“Rules for the Survey and Construction of Steel Ships” has been partly amended as follows:

Part CSR-B Common Structural Rules for Bulk Carriers

Paragraph 9.6.3 has been amended as follows.

9.6.3 Corner of hatchways

Fig. 25 Hatch corner insert plate

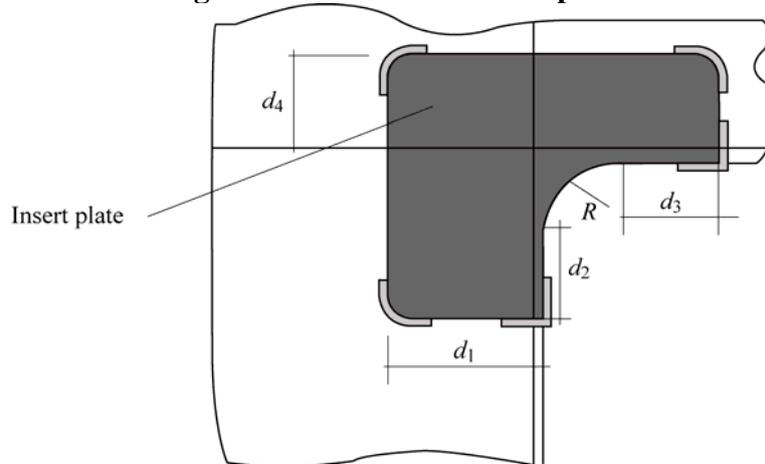
Where insert plates are required, the arrangement is shown in **Fig. 25**, in which d_1 , d_2 , d_3 and d_4 are to be greater than the ordinary stiffener spacing.
